Docket Item # 5
BAR CASE # 2009-0074

BAR Meeting
May 6, 2009

ISSUE: Alterations
APPLICANT: Mitchell Bober
LOCATION: 325 South Lee Street
ZONE: RM Residential

Figure 2. Proposed garden gate and masonry arch.

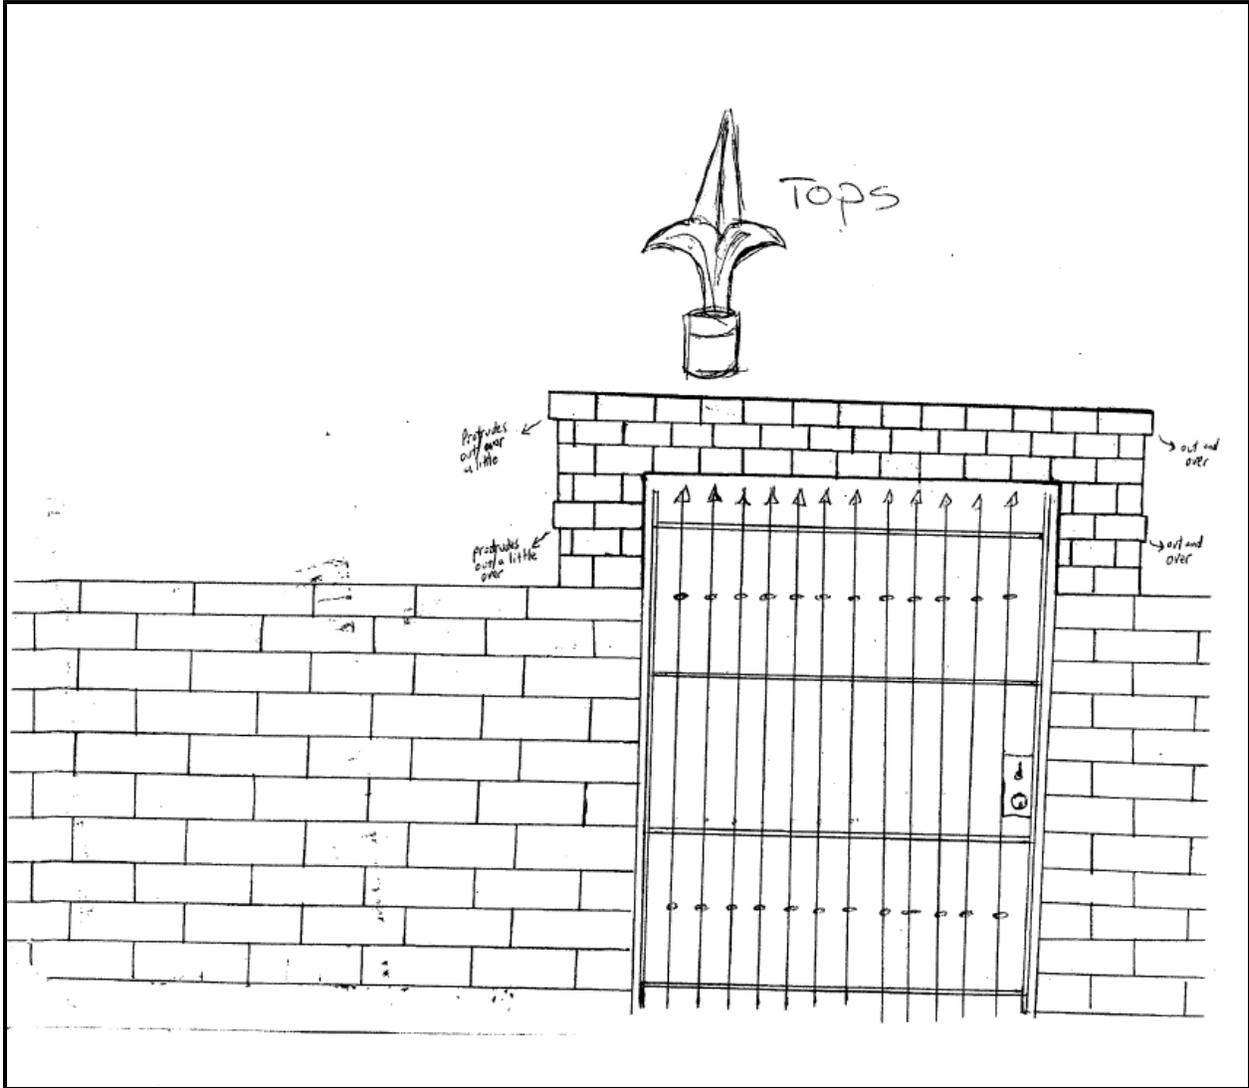
The applicant is requesting approval of a Certificate of Appropriateness for alterations at 325 South Lee Street. The applicant is proposing the replacement of an existing garden gate and the construction of a new brick arch above the gate which will be mounted to the existing garden wall. The existing wooden gate that the applicant has requested to replace is in a state of disrepair. The applicant is proposing the installation of a new wrought iron garden gate with minimal decorative detail. The proposed masonry arch will be constructed of seven brick courses above the existing brick garden wall where the third course of brick will be constructed as a belt course. The applicant has indicated that he intends to use brick and mortar to match the existing brick wall in construction of the new arch.

According to the *Design Guidelines*, "Fences, garden walls and gates should be appropriate in materials, design and scale to the period and character of the structure they surround" In Staff's opinion, the proposed wrought iron gate and brick arch are in keeping with both the period and style of the home. Additionally, as stated in the *Design Guidelines*, "A number of different types of materials are appropriate for fences, garden walls and gates throughout the historic district," therefore Staff has no objection to the applicant replacing the existing wooden gate with a wrought iron gate. Staff finds the proposed iron gate to be an improvement both visually and spatially.

Staff recommends approval of the application as submitted.
